Subject: Duke Energy Corporation  
Oconee Nuclear Station, Units 1 and 2  
Docket Numbers 50-269, 50-270, and 50-287

Technical Report NFS-1001A, Revision 5,  
January 2001, *Reload Design Methodology*

**DUKE POWER COMPANY  
OCONEE NUCLEAR STATION  
RELOAD DESIGN METHODOLOGY  
Technical Report NFS-1001A**

RESPONSES TO NRC QUESTIONS  
OF  
OCTOBER 16, 1980

Figure 1-1

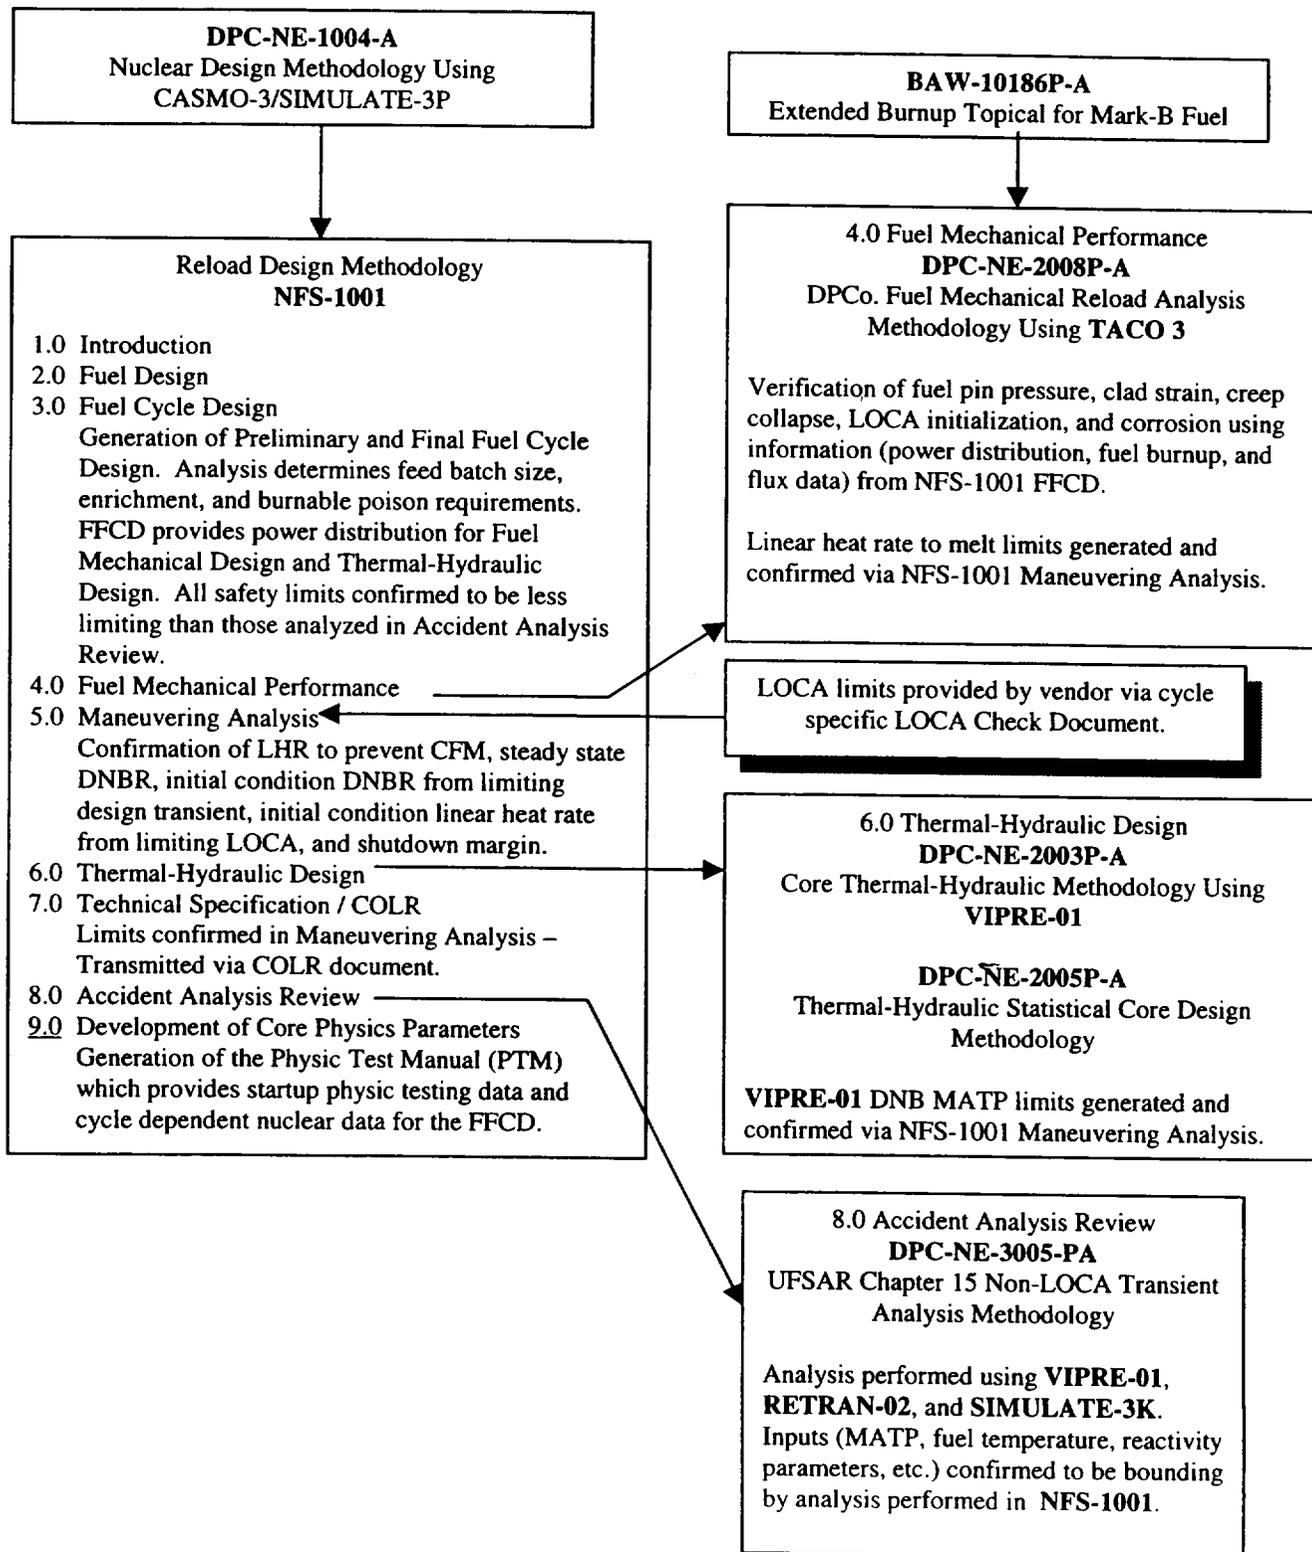
12. The methodologies used to develop the core physics parameters in chapter 9 need to be stated or referenced. (Page 42)
13. Figure 1-1 should reference the approved version of DCP-NE-3005. (Page 5)

13. Question: Figure 1-1 should reference the approved version of DPC-NE-3005. (Page 5)

Response: Figure 1-1 has been revised as stated.

Figure 7-4

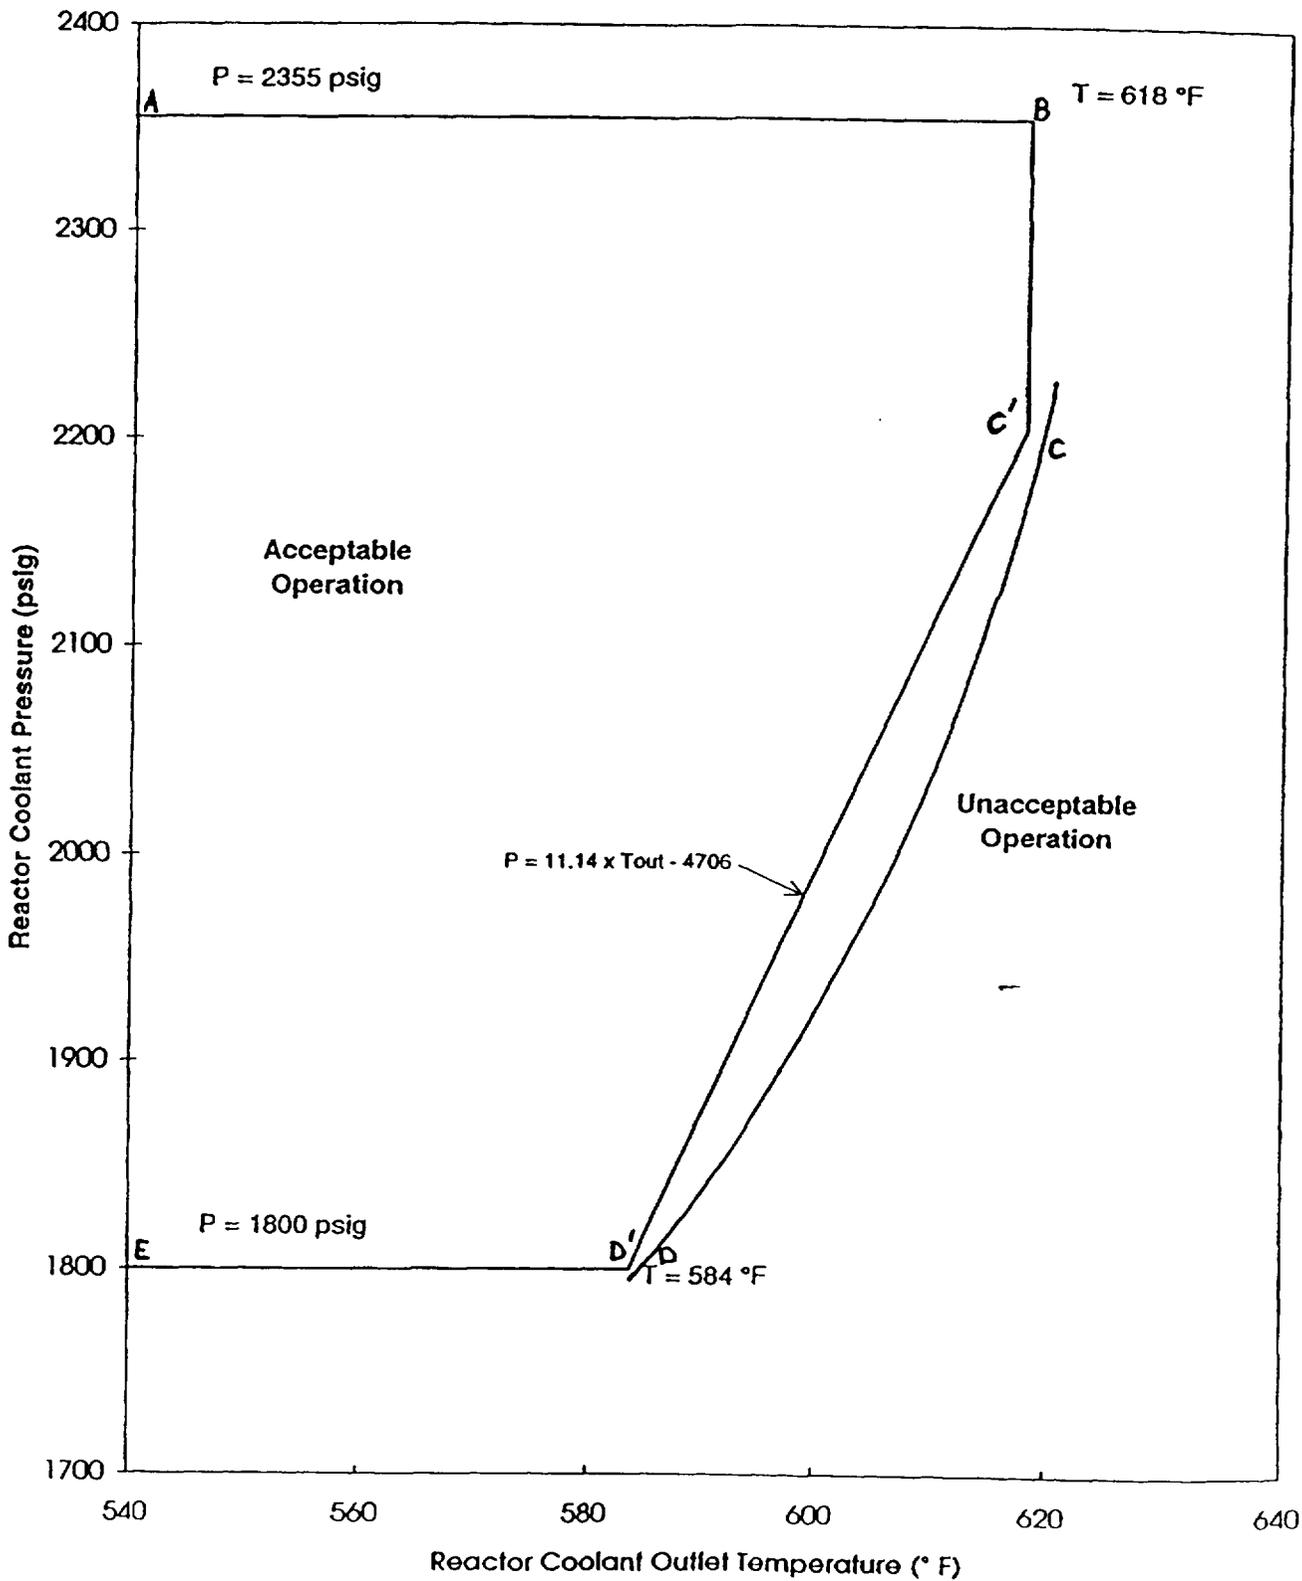
In determining the reactor protection system P-T set points, the applicant stated that the RCS high pressure trip set point was 2356 psig. In the Technical Specifications for Oconee Units 1, 2, and 3, the high pressure trip is at 2300 psig. Correct this discrepancy.

- 1) Paragraph 2, page 7-0
- 2) Table 7-1, page 7-16
- 3) Figure 7-4, page 7-20

Figure 7-5

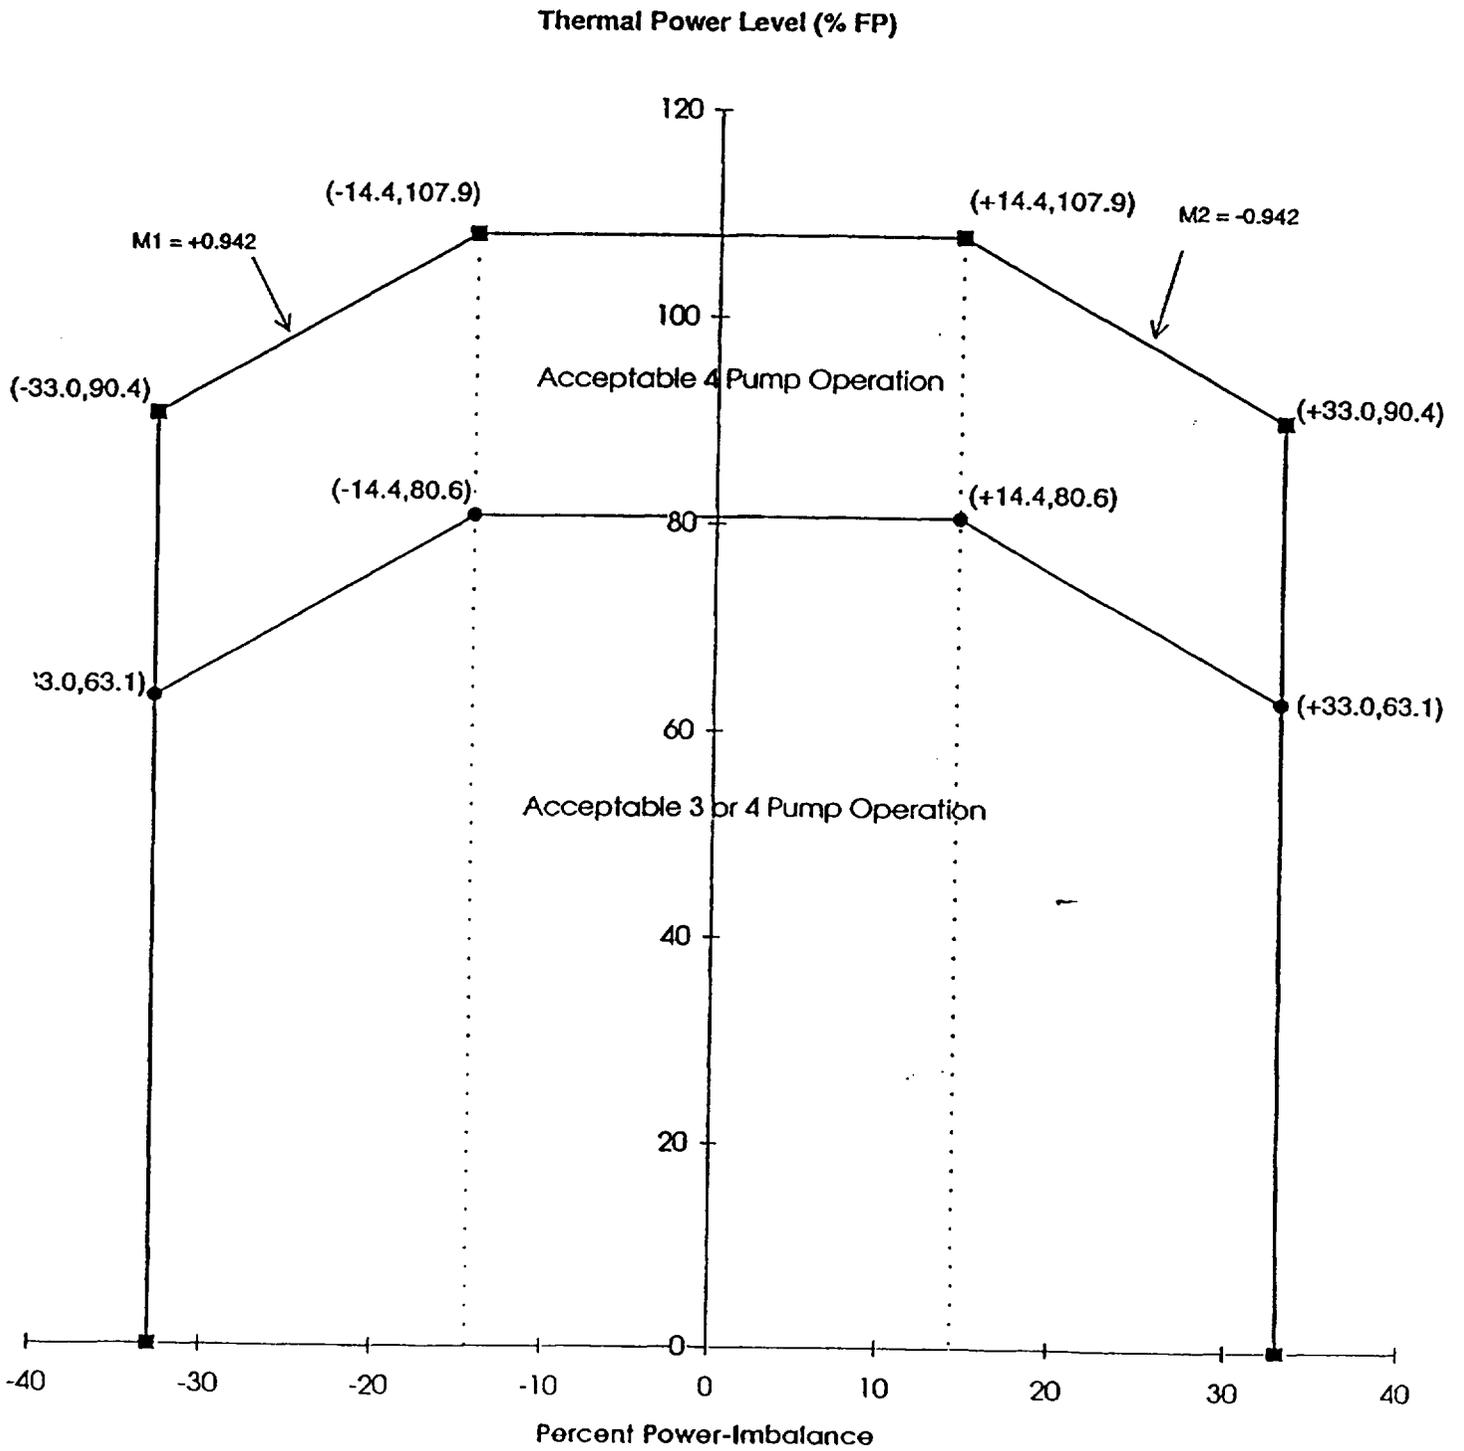
14. For the determination of the power-flow-imbalance trip setpoint, how is the allowable power-to-flow ratio obtained? Figure 7-5 displays the power-power imbalance portion of the trip function, however, it does not appear to display the power-to-flow ratio portion of the trip function. Please include an example display of the power-to-flow ratio portion of the trip. (Page 25)

14. Question: For the determination of the power-flow-imbalance trip setpoint, how is the allowable power-to-flow ratio obtained? Figure 7-5 displays the power-power imbalance portion of the trip function, however, it does not appear to display the power-to-flow ratio portion of the trip function. Please include an example display of the power-to-flow ratio portion of the trip. (Page 25)

Response: DPC-NE-2003P-A (reference 5) describes how the analysis of the loss of flow event is utilized to obtain the power-to-flow ratio. This is illustrated in Figure 7-5 as the reduction in allowable power level from four-pump flow to three-pump flow.

Figure 4-1. (FSAR Figure 14-1)

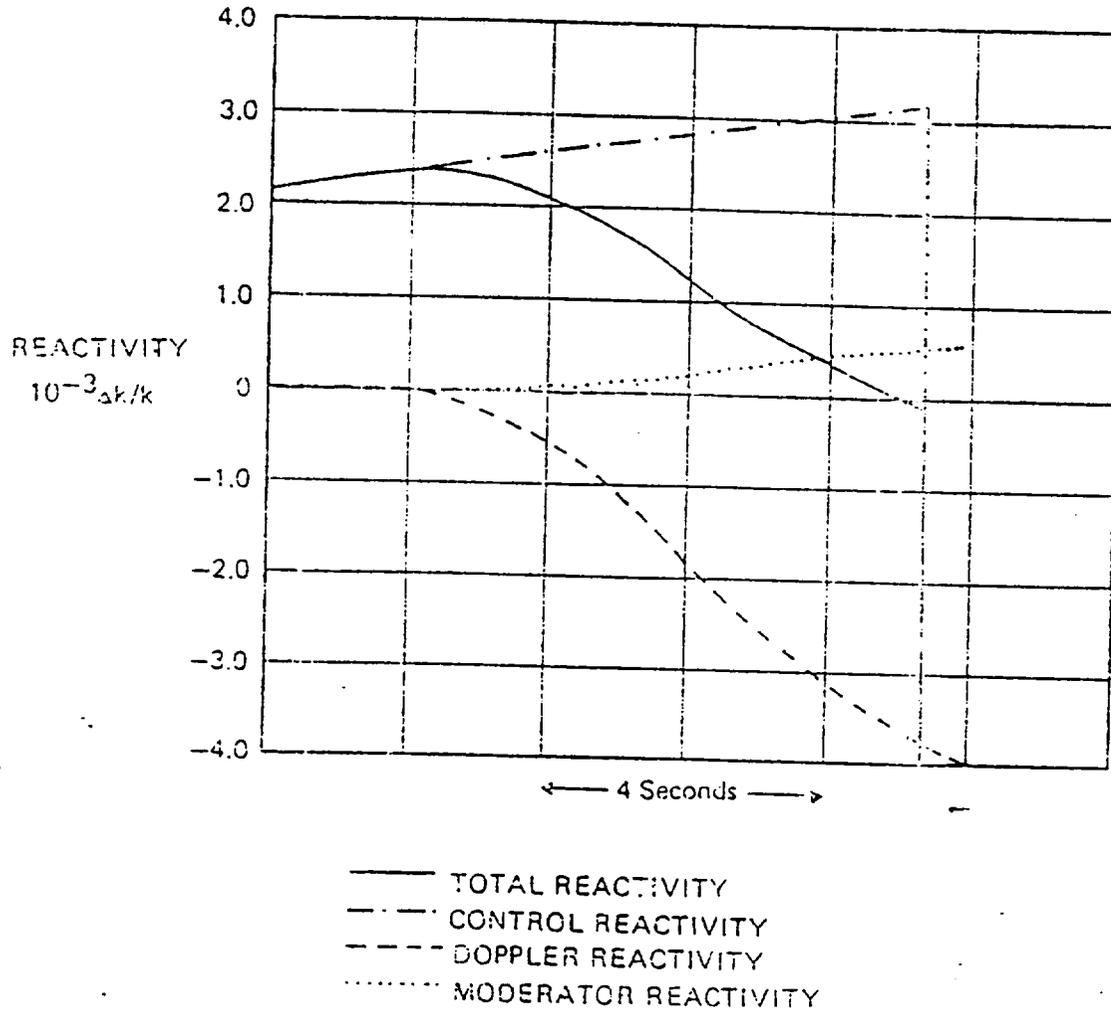
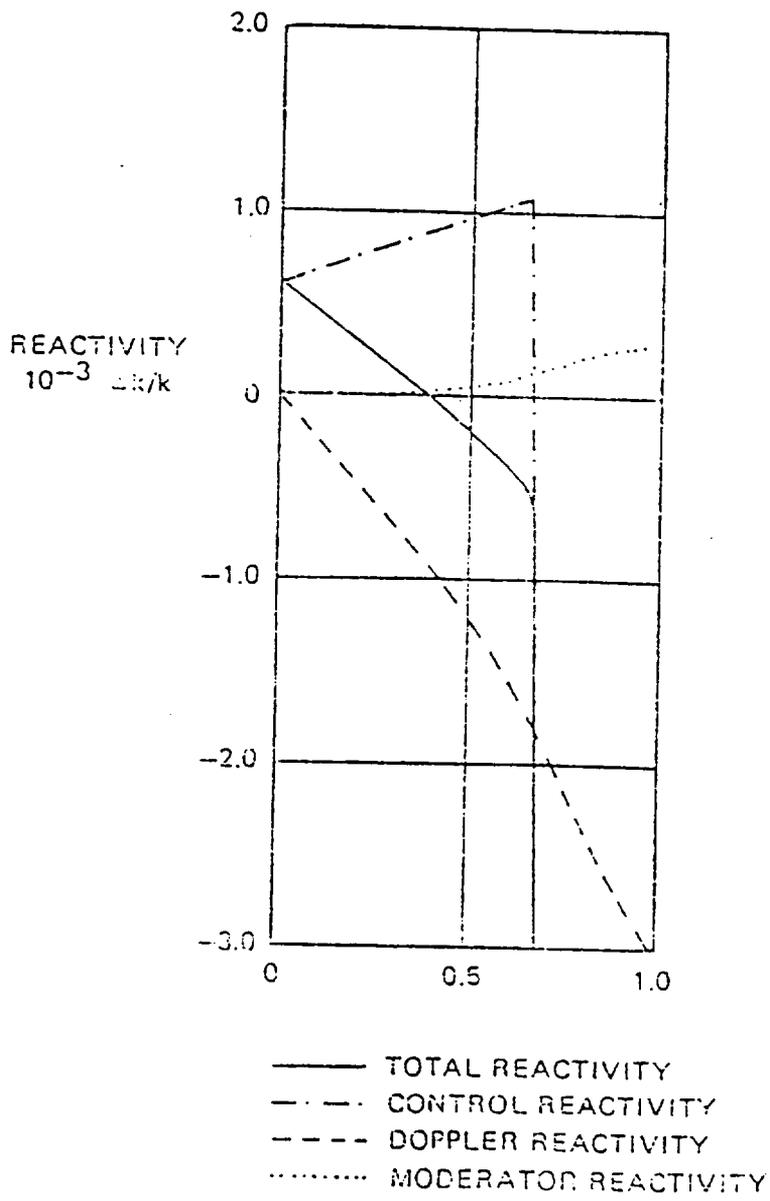
Question 4 requests additional information for the start-up accident concerning the variation of the components of the reactivity response. These parameters are an intermediate output of the analysis whose response is indicated by other documented parameters such as power level, but are not normally included in the analysis documentation. However, the components of the reactivity response are determined by the parameters which are reviewed and shown to be within the bounds of the FSAR analysis. The reactivity response determined by those parameters remains valid until the value of a parameter is no longer bounded for a reload core. The safety review methodology of Section 8 assures the identification of all pertinent reload core parameters affecting the reference safety analysis, confirmation of the validity of the reference safety analysis for the reload core, and the resolution of any non-conservative parameter.

In order to respond to the question, the variation of the total reactivity and its components were calculated from the results presented in FSAR Figures 14-1 and 14-2, utilizing the analysis assumptions specified in the FSAR. The variation of the total reactivity during a startup accident is the sum of three reactivity effects. The withdrawal of the control rod banks adds positive reactivity which causes the neutron power level to increase and raise the average core temperature. The increase in fuel temperature causes a negative reactivity feedback due to the negative Doppler coefficient. The increase in power level increases heat transfer from the fuel to the coolant, resulting in an increase in moderator temperature. This causes a positive reactivity feedback since a positive beginning of cycle moderator coefficient is assumed. The transient response is primarily determined by the rate of positive reactivity addition from the withdrawal of rods, and the Doppler feedback which slows or terminates the nuclear excursion. The moderator feedback has a smaller effect. Figures 4-1 and 4-2 show the variation of the reactivity consistent with FSAR Figures 14-1 and 14-2 respectively. It should be noted that these figures do not represent the first 10 seconds of the transients, considering that the initial conditions are  $10E-9$  rated power and 1% k/k subcritical. Figures 4-1 and 4-2 illustrate the time interval of greatest interest during the transient, Figure 4-1 is the same scale as Figure 14-1, and Figure 4-2 is the first one second of the response in Figure 14-2. For both transients the reactivity addition for the first 10 seconds following initiation of rod withdrawal would only cause a reduction in the subcriticality margin.
